**Subject: Beaver Valley Power Station, Unit Nos. 1 and 2
Docket No. 50-334, License No. DPR-66
Docket No. 50-412, License No. NPF-73
Unit No. 1, Cycle 14 and Unit No. 2, Cycle 9 Core Operating Limits
Report Updates**

Beaver Valley Power Station, Unit No. 1
Core Operating Limits Report, Cycle 14, Revision 19

Beaver Valley Power Station, Unit No. 2
Core Operating Limits Report, Cycle 9, Revision 19

Figure 4.1-5
REACTOR CORE SAFETY LIMIT
THREE LOOP OPERATION
(Technical Specification Safety Limit 2.1.1)

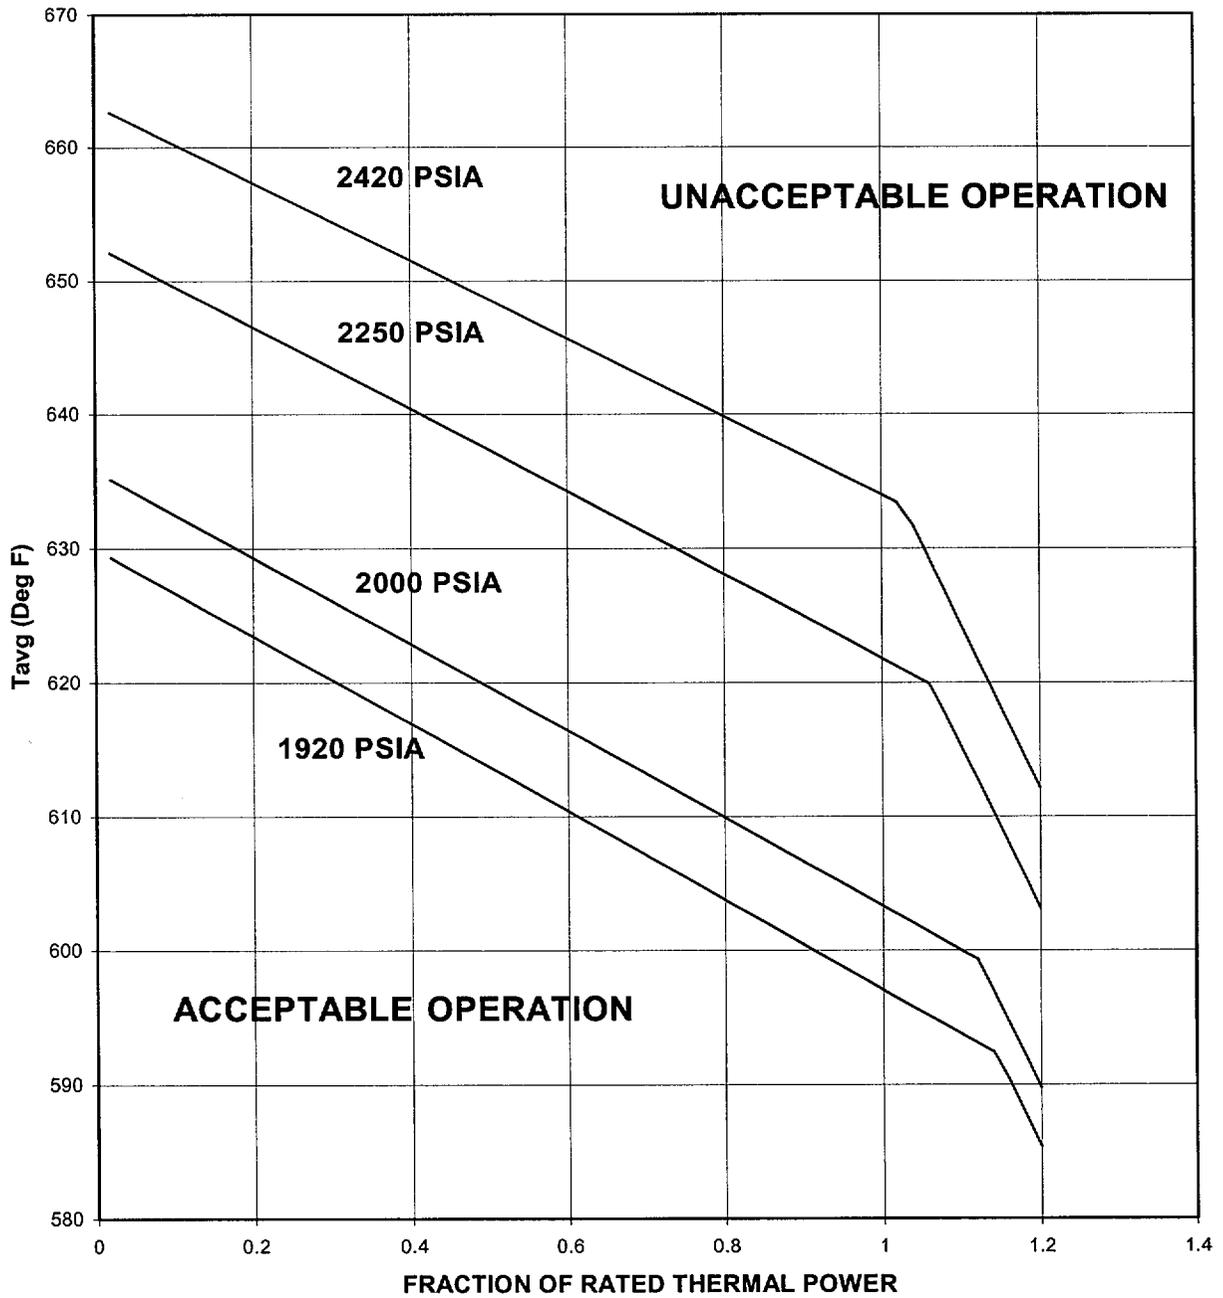
Midcycle revisions to the Beaver Valley Power Station (BVPS) Unit Nos. 1 and 2 Core Operating Limits Report (COLR) are provided herein pursuant to Technical Specification (TS) 6.9.5.d. The COLR for each unit has been revised to incorporate TS relocations and other changes that result from the implementation of Amendment Nos. 239 and 120, "Revised Thermal Design Procedure," for the remainder of fuel cycle 14 and fuel cycle 9, for BVPS Unit Nos. 1 and 2, respectively. Amendment Nos. 239 and 120 were approved and issued by the NRC on July 20, 2001, and supplemented by NRC letter dated July 30, 2001. The affected COLR pages for Unit No. 1 are provided as Attachment 1, and the affected COLR pages for Unit No. 2 are provided as Attachment 2.

4.1-7 (new)

4.1-8 (new)

4.1-9 (new)

Figure 4.1-5
REACTOR CORE SAFETY LIMIT
THREE LOOP OPERATION
(Technical Specification Safety Limit 2.1.1)

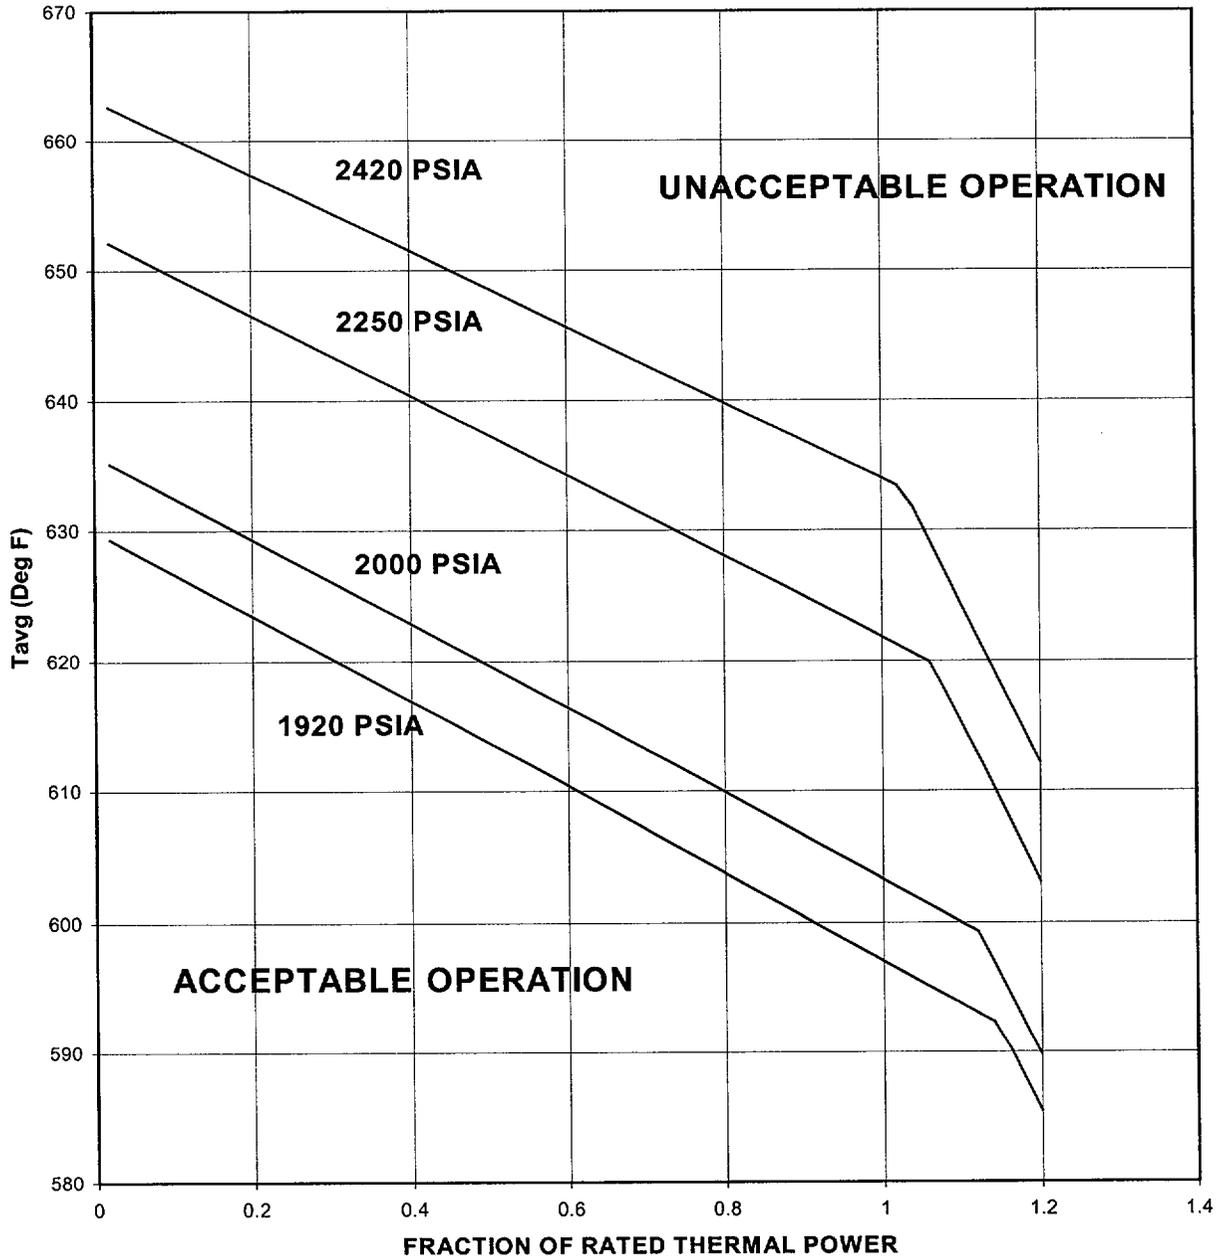
4.1-7 (new)

4.1-8 (new)

4.1-9 (new)
